Subject: AP1000 COL Responses to Requests for Additional Information (SRP3.7.1)

Responses to Requests for Additional Information on SRP Section 3.7.1

# AP1000 TECHNICAL REPORT REVIEW

**Figure 1.0-1: Comparison of the HRHF horizontal input spectra to the CSDRS**

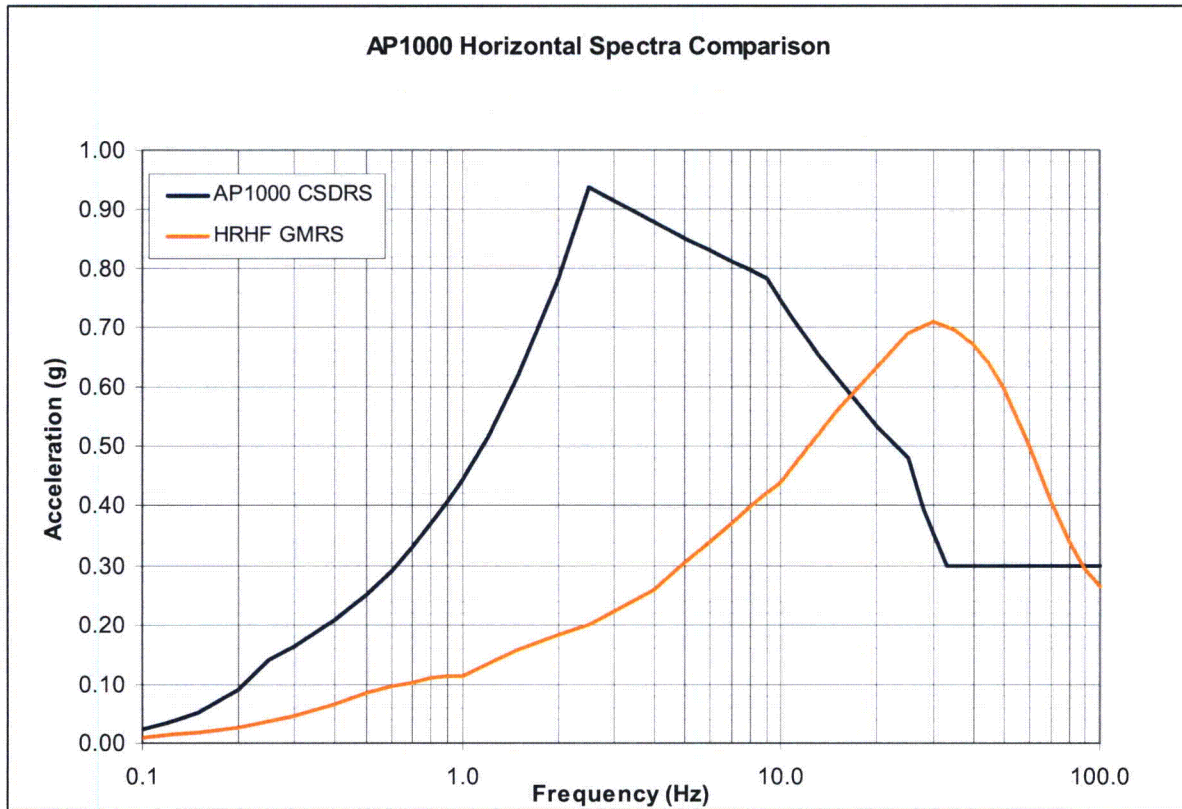
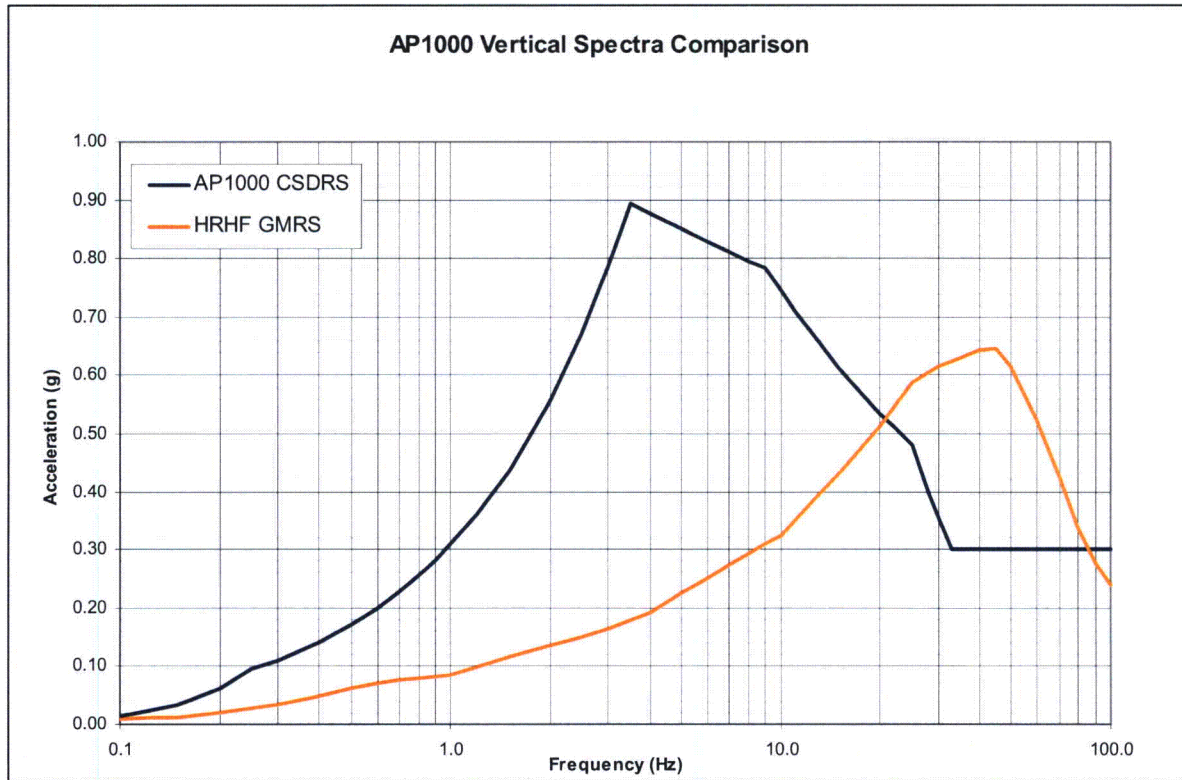
The purpose of the report is incorrectly stated, and may lead a reader to an incorrect conclusion. (1) and (2) above apply at best to the HRHFRS that Westinghouse has defined in this report (as further revised in TR-144), which supposedly envelope the 3 currently proposed CEUS hard rock sites. As stated above, a reader may reach the conclusion that Westinghouse's two-fold purpose applies generically to "high frequency seismic input". The staff requests that Westinghouse accurately state the purpose of TR-115.

This paragraph is also misleading, and may lead a reader to an incorrect conclusion. The staff requests that Westinghouse accurately state what has been specifically demonstrated in TR-115.

Modify Figures 1.0-1 and 1.0-2 to be consistent with Figures 5.0-3 and 5.0-4 given in TR-144.

Figure RAI-SRP3.7.1-SEB1-07-01: Comparison of Horizontal Response Spectra

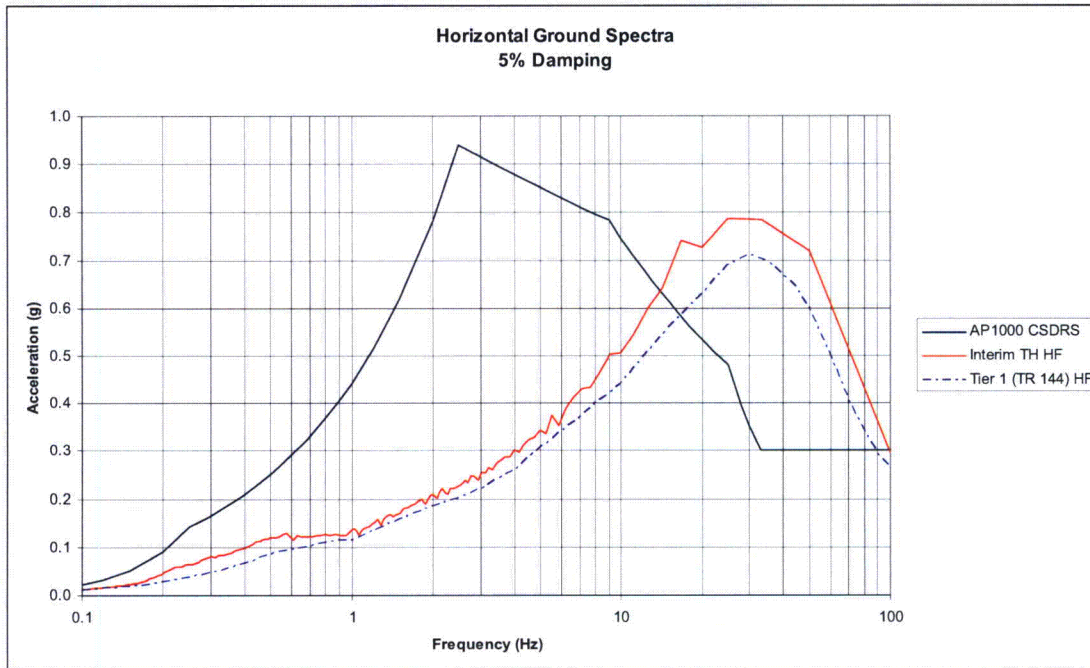
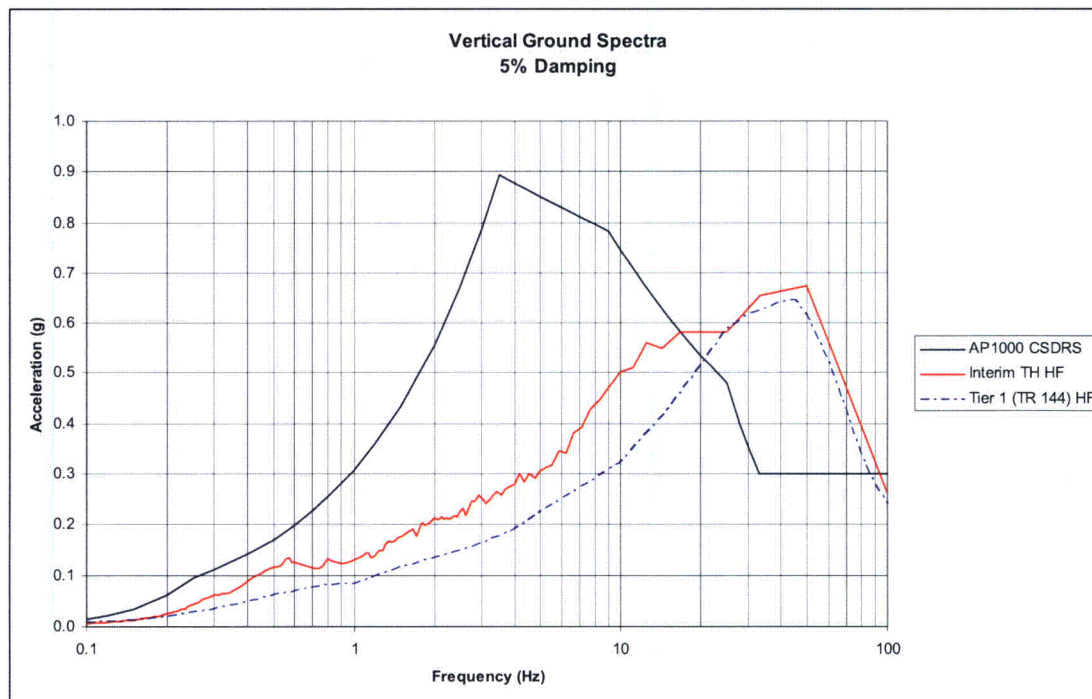
The spectral comparisons in TR-115 Figures 5.1-1 through 5.1-3, between NI10 results and NI20 results, are insufficiently described. The staff requests that Westinghouse identify what seismic input to the buildings produced these in-structure response spectra.

The staff notes that if the CSDRS synthetic time histories were used, the comparison is of questionable value, because the CSDRS do not have amplification at high frequency. To clearly show the adequacy or inadequacy of the NI20 model for analysis of the HRHFRS, the staff requests that Westinghouse perform NI10 and NI20 fixed base analyses, using the un-modified HRHFRS synthetic time histories as input, without any reduction for incoherency or other considerations, and present the comparison of results.

The spectral comparison in TR-115 Figures 5.1-1 through 5.1-3, between NI10 and NI20 results, use a fixed base analysis. An interim high frequency synthetic time history without any reduction for incoherency was used. This time history was created earlier than the HRHF time histories used to evaluate structures and equipment in TR-115 (see RAI-SRP3.7.1-SEB1-01). As seen in Figures RAI-SRP3.7.1-SEB1-07-01 and RAI-SRP3.7.1-SEB1-07-02 the seismic response is higher than that associated with the time histories used for evaluation and documented in TR-115.

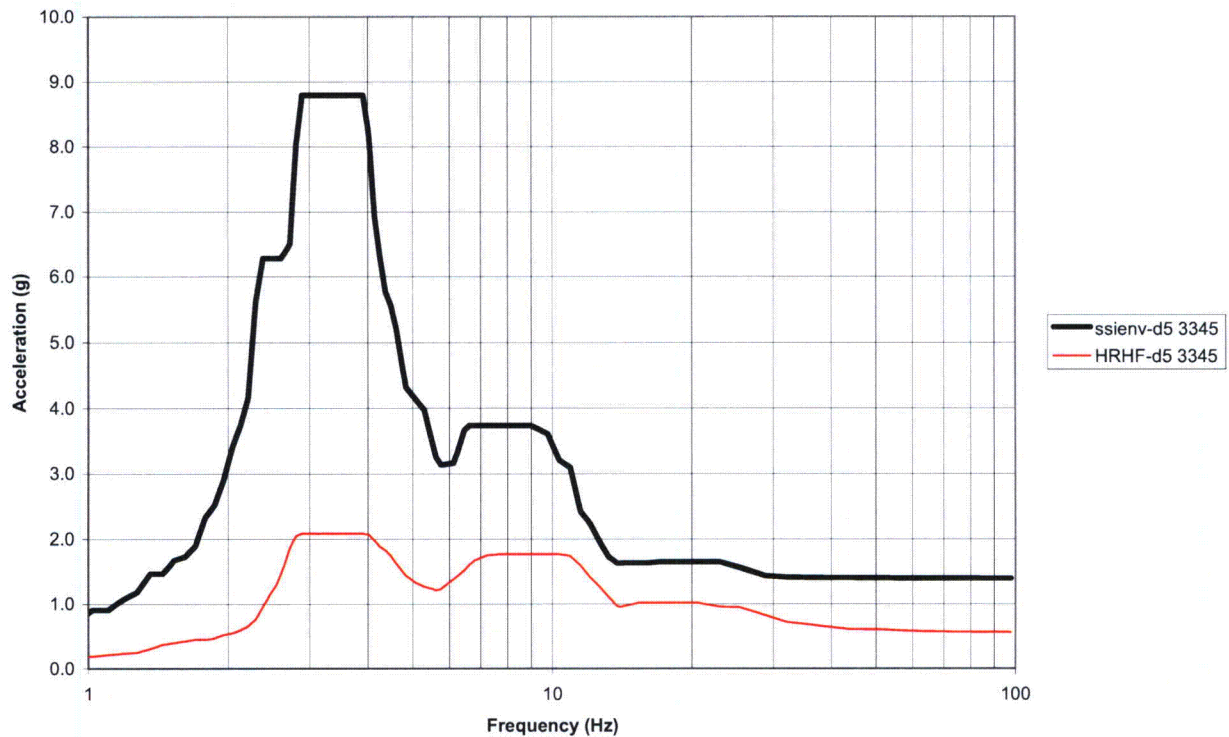
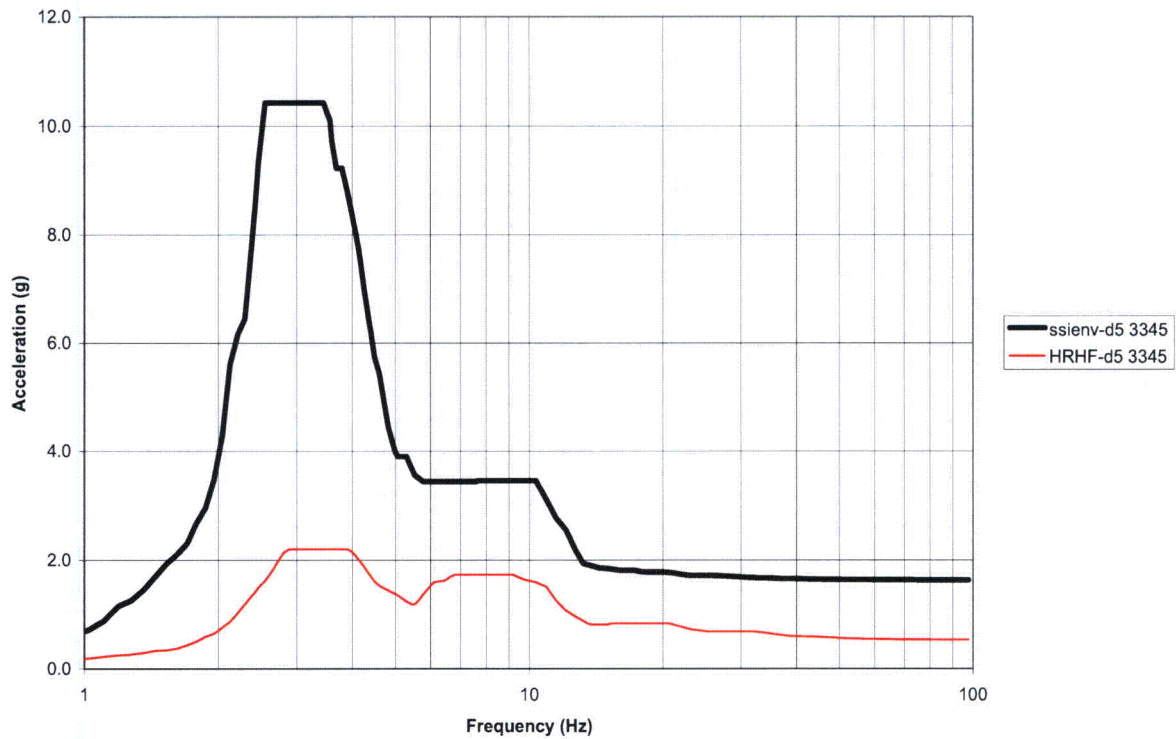
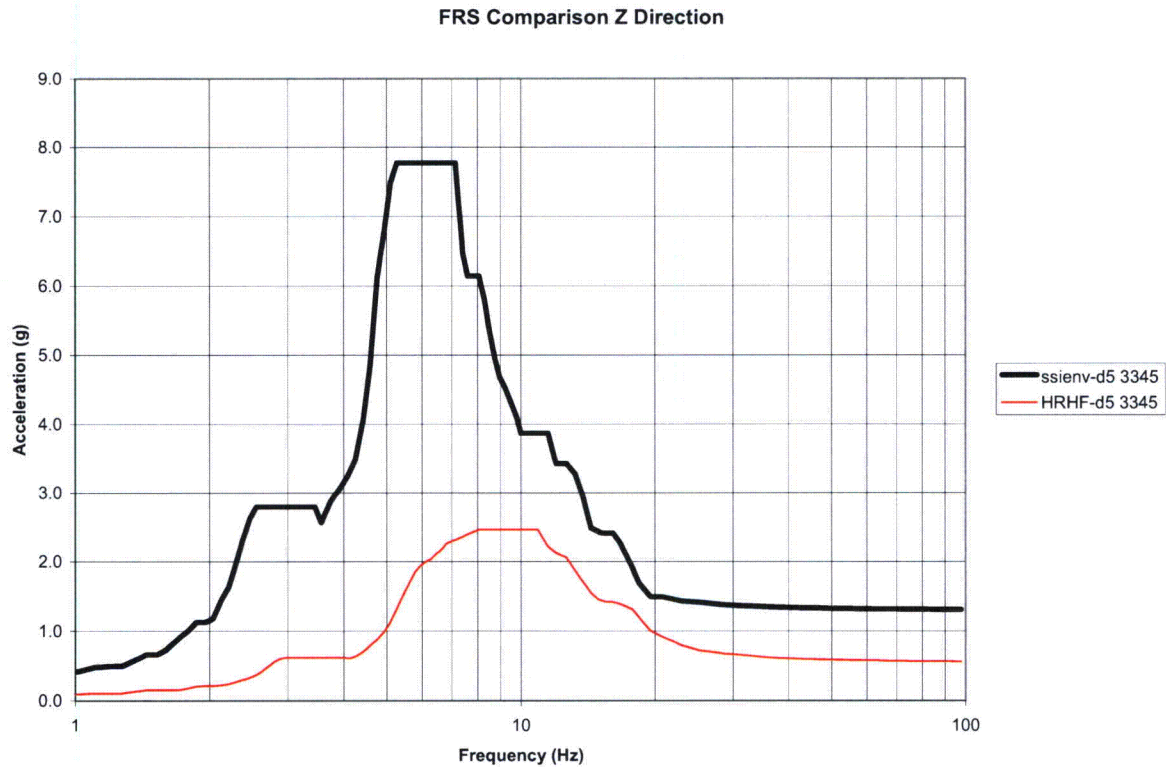
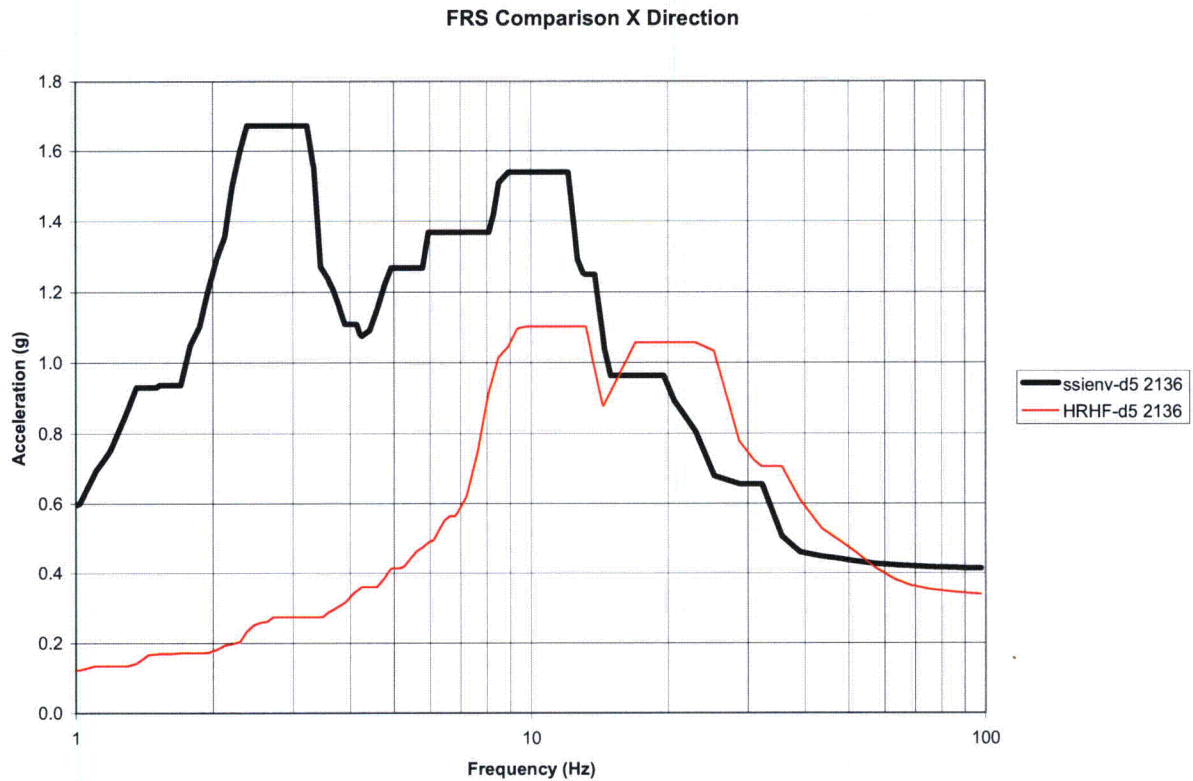
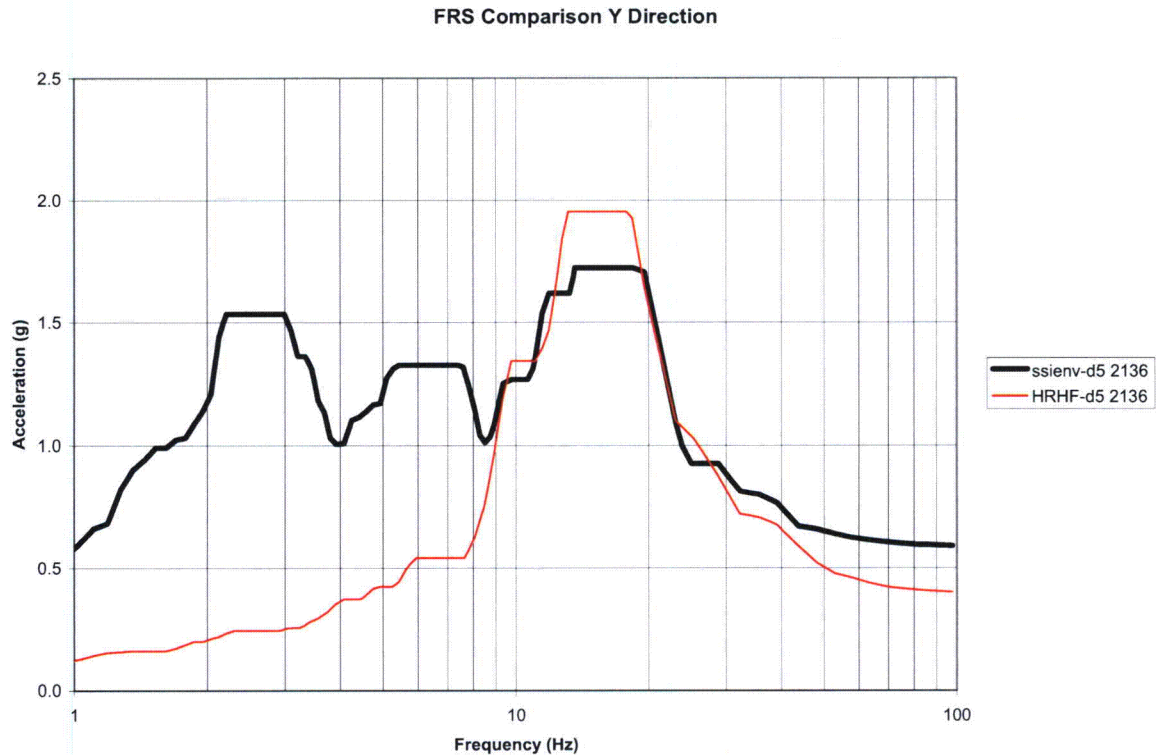
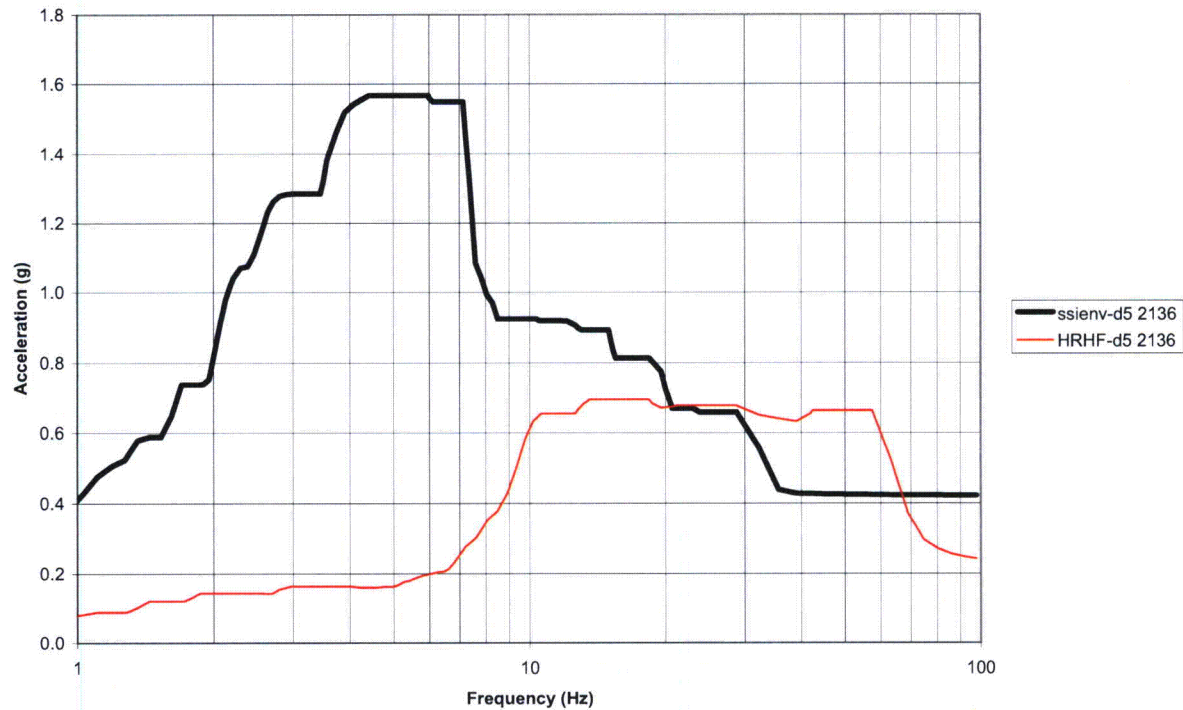
The staff noted that improved, more readable Figures 5.2-1 through 5.2-6 in TR-115 are needed. The ordinate scale and the legend cannot be read even by zooming in the electronic file. High resolution printing makes them barely readable. The staff requests that Westinghouse submit larger, readable copies of Figures 5.2-1 through 5.2-6, to facilitate the staff's evaluation of the information.

The requested figures are found in Figures RAI-SRP3.7.1-SEB1-09-01a to RAI-SRP3.7.1-SEB1-09-06c.
